PLAN COMMISSION/HISTORIC PRESERVATION COMMISSION WEDNESDAY, JULY 26, 2017

To: Village of Mount Horeb Plan Commission
From: Village Planner Michael A. Slavney, FAICP
Date: 18 July 2017
Re: Design Review for the Mount Horeb Public Safety Building Project.

From: Robert Wright [Robert.Wright@smithgroupjjr.com]
Sent: Monday, July 17, 2017 6:33 PM
To: Kathy Hagen; Nic Owen
Cc: Chad Wuebben (cwuebben@encorebuildsmadison.com); 'Wade Wyse'
Subject: Maple Ridge Plat: Review Comments
Attachments: Maple Ridge Design Plans - SGJJR Comments.pdf

Sheet Number:
C1.0

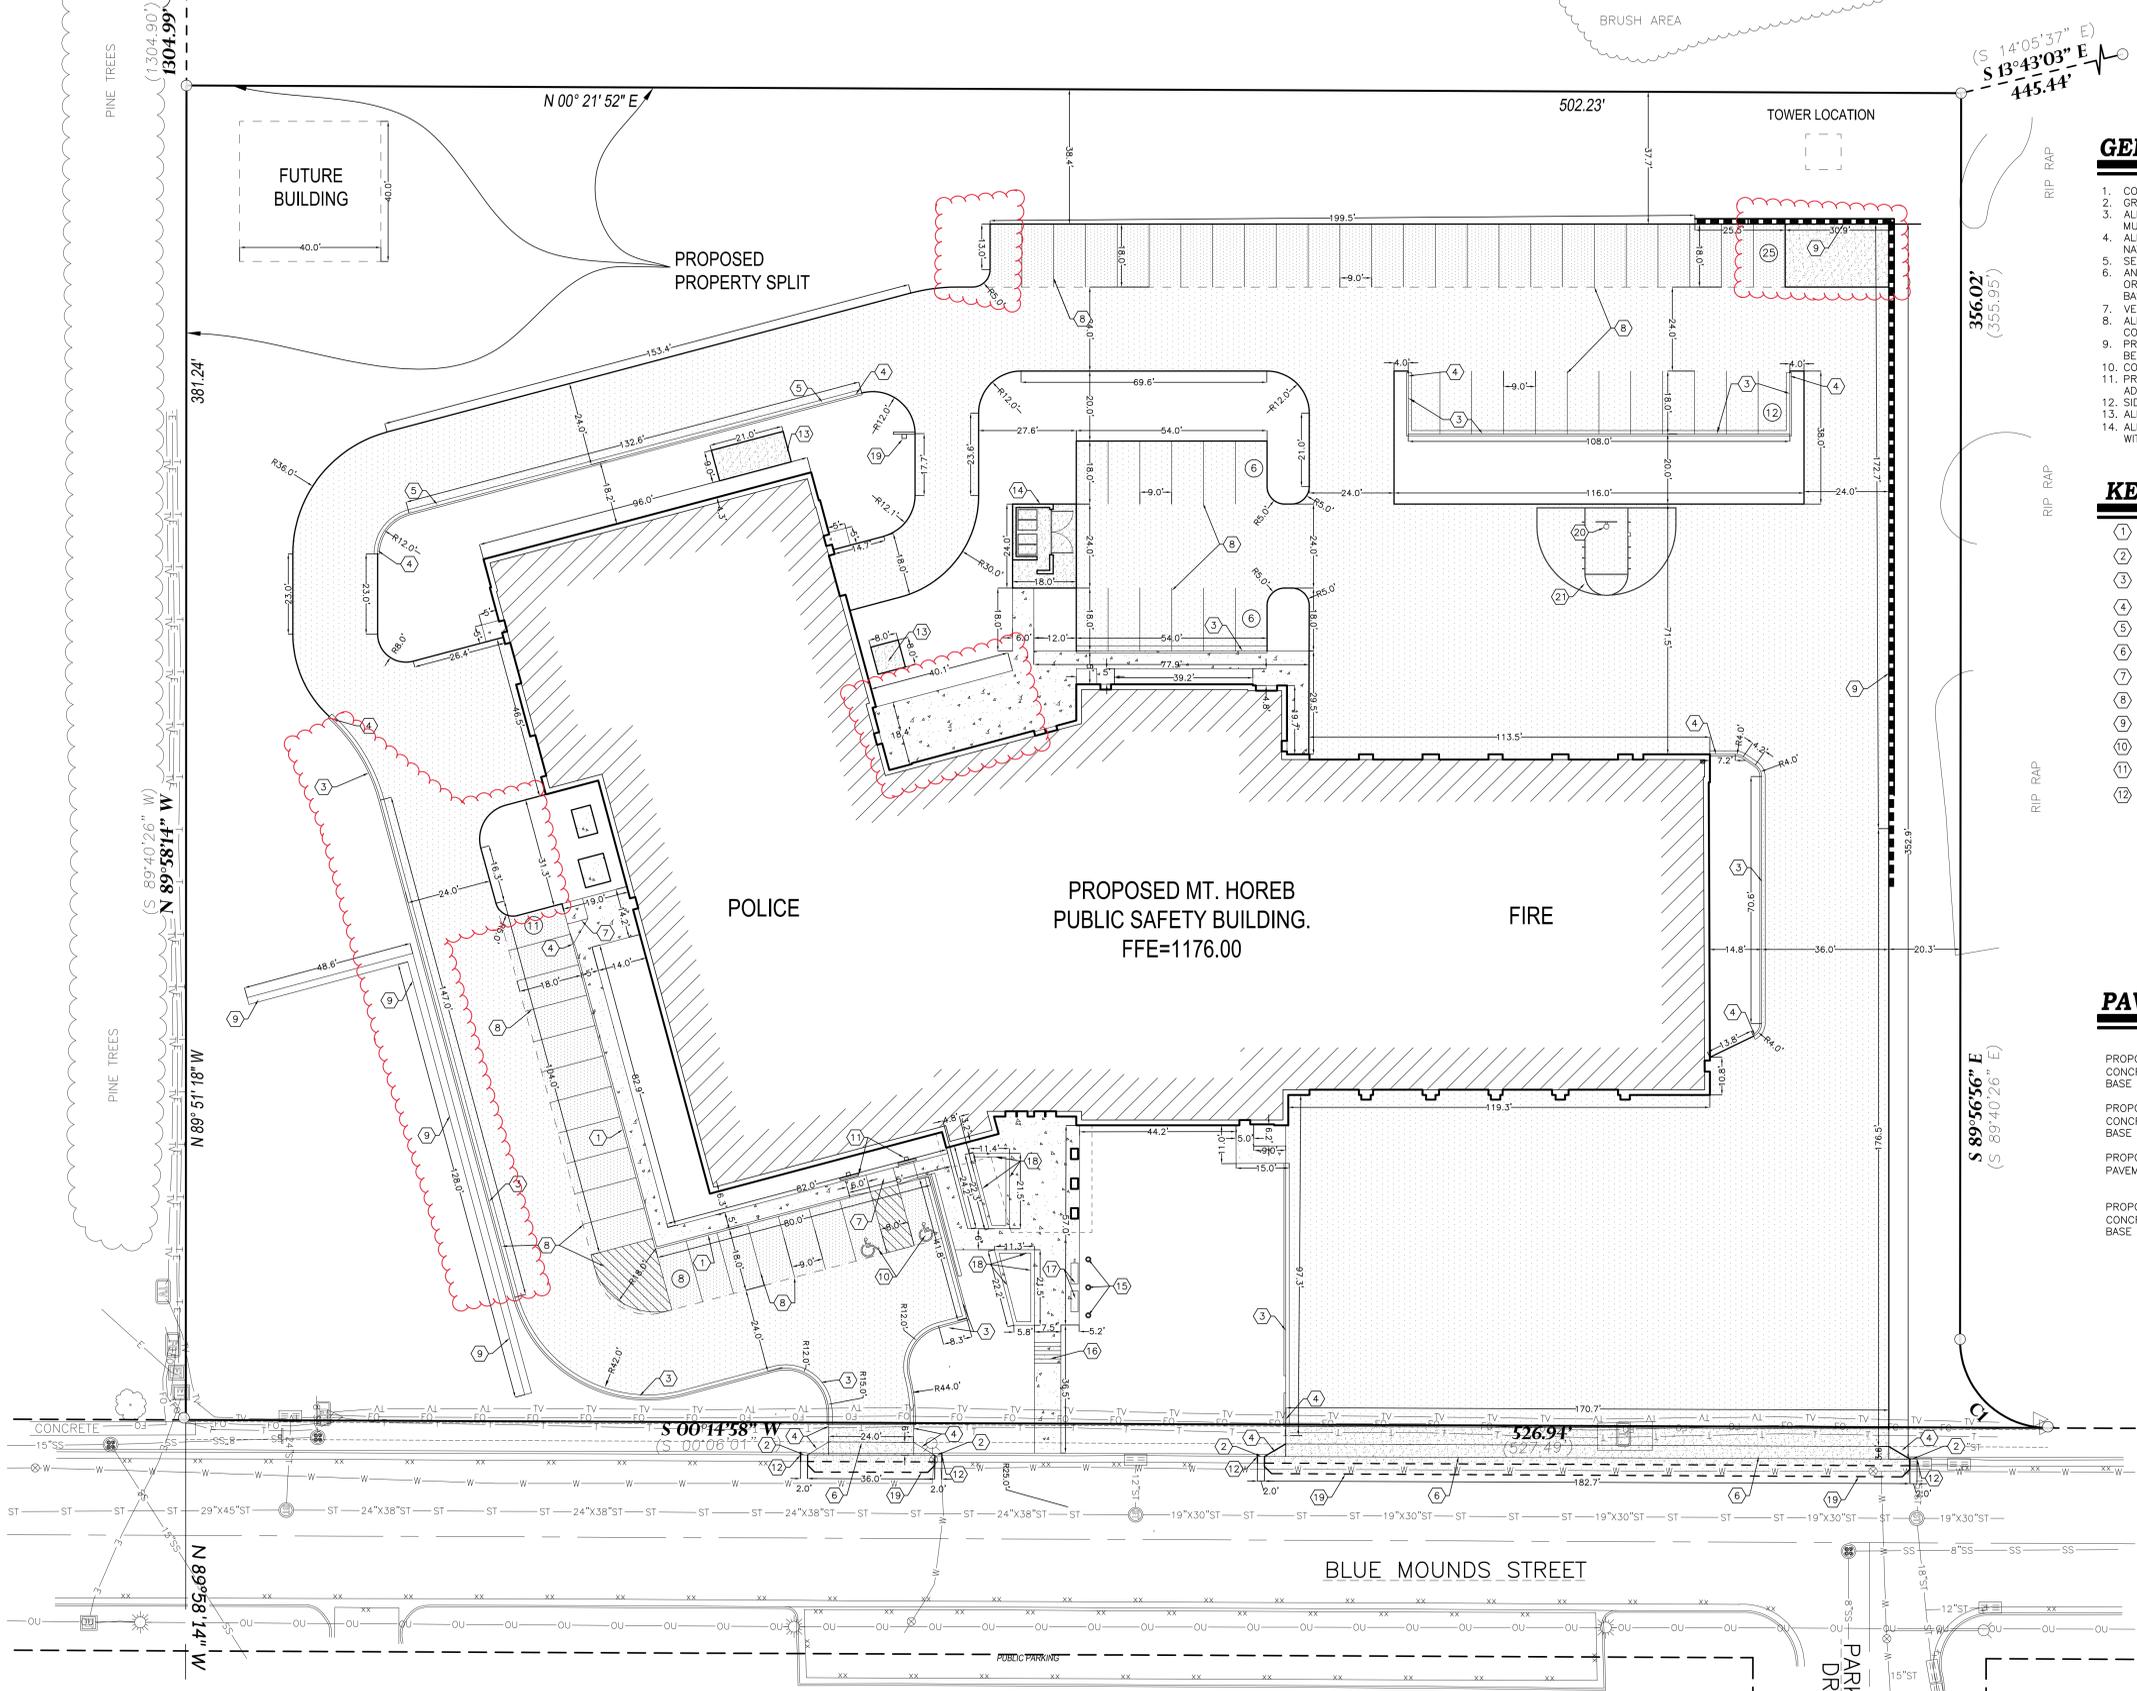
- ✓ As shown on Sheet C1.0, the Layout Plan, and Sheet C2.0, the Grading Plan, the proposed development and grading affects about 95% of the subject property. However, the subject property is historically farmed, and has no significant vegetation. The double-row spruce buffer to the south is located on the adjoining property, and will not be affected by the proposed development. Curbs will be used along the south side of the paved area to guide stormwater to basins in the southeast corner of the subject property.

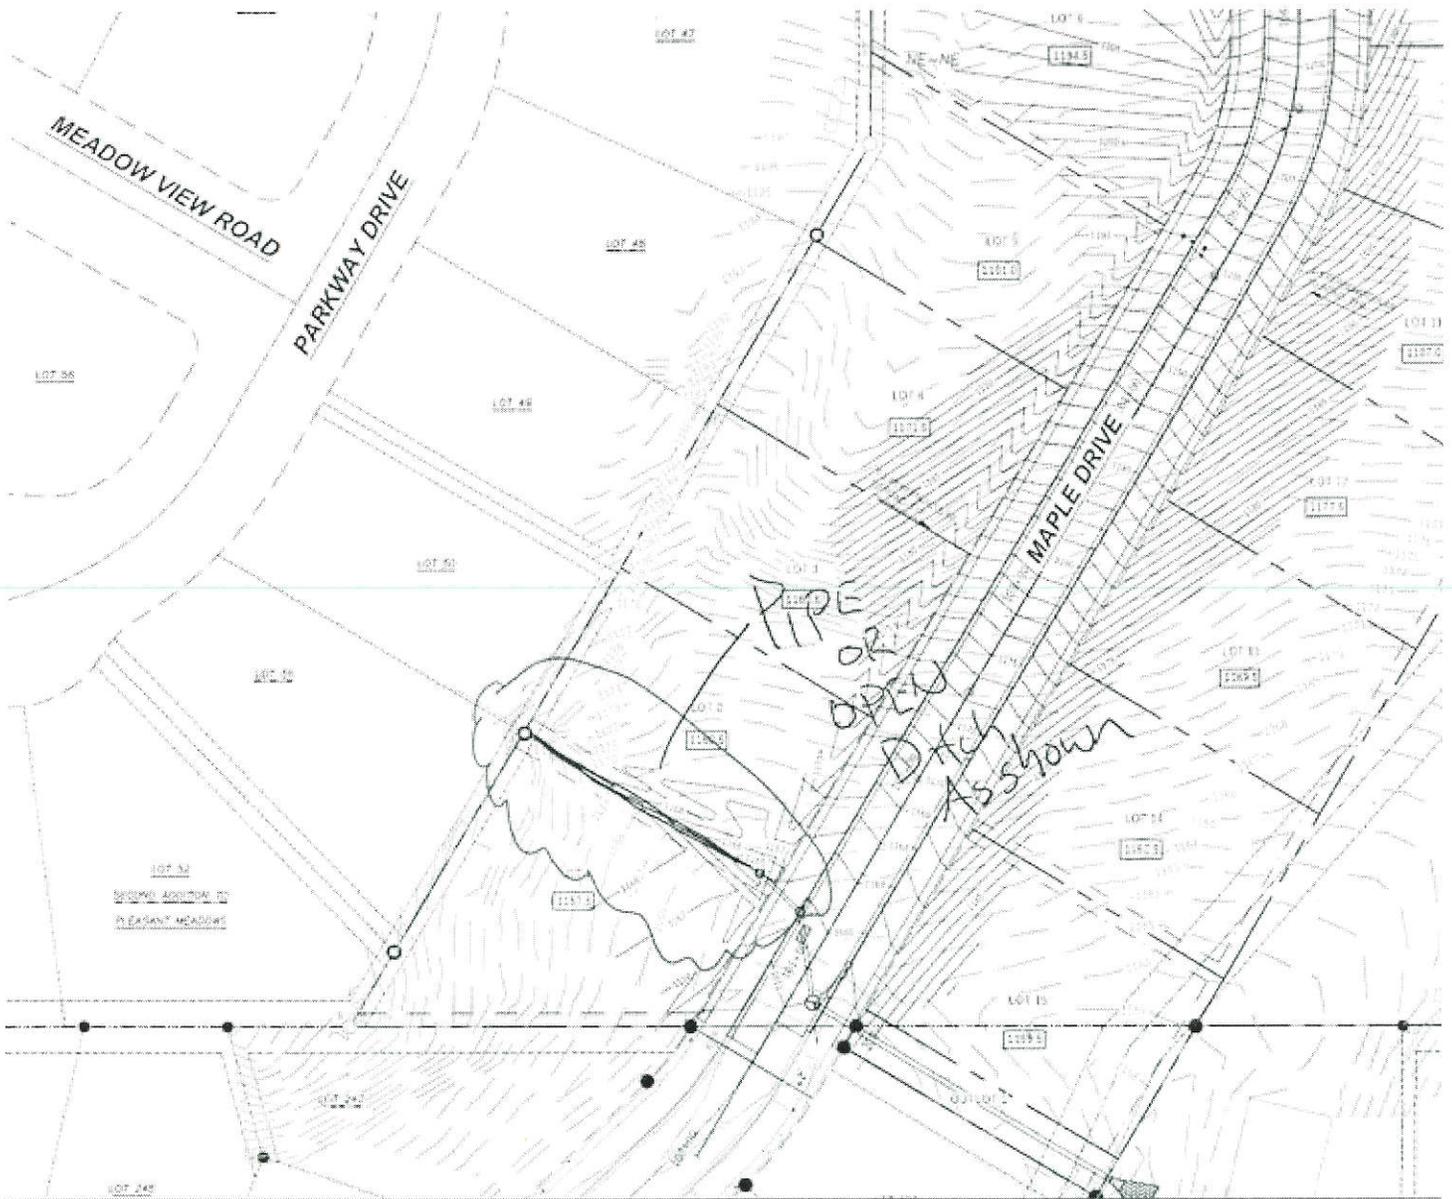
3. Ditch checks should be added in the berms
4. Label typical slopes on grading
5. Sewer and water laterals may be better suited to be installed in the lower 1/3 of the lot to allow for basement exposure.

6. Label Station offsets and tapers on P-2 of the connection to the North end. Tapers should be at 10:1 maximum
7. Sheet P-3 – consider connection with a pipe between STM MH NO. 3 to the existing storm sewer on the west side of the plat. Because the pipe is out of the traveled way, N12 or PVC ultra-rip may be used in lieu of RCP pipe. If possible shift STM MH NO. 3 to be located on the intersection of the common lot line of Lots ½

8. Verify manhole size of STM MH NO.2
9. Standard sidewalk width in residential areas is 4-ft
10. Dimension distances between Sewers and water main on plan and profile sheets.

- 1. Drainage arrows required.
- 2. Additional language regarding utility easements and the purpose and intent should be added to the face of the plat.
- 3. Master site grading plan is required.

It appears that many of the comments were taken care of in this 85% submittal. The one comment that should be discussed by the Village is the open drainage ditch (located with a drainage easement to the Village) that is between Lots 1 and 2 on the west side of the roadway. This ditch picks up a storm sewer outfall that is between lots 50/51 on the plat to the west. I had previously noted that the developer may want to look at a yard inlet in this location near the road instead of a rip rap ditch with apron end wall or potentially piping it. This submission changes this area to a yard inlet as was suggested as one of the two potential changes that could be made. Fully piping this may be a better solution for the adjoin lots as the drainage way could be a maintenance issue for both the village and owners of the lots.

Also, a Master Site Grading Plan is still required.
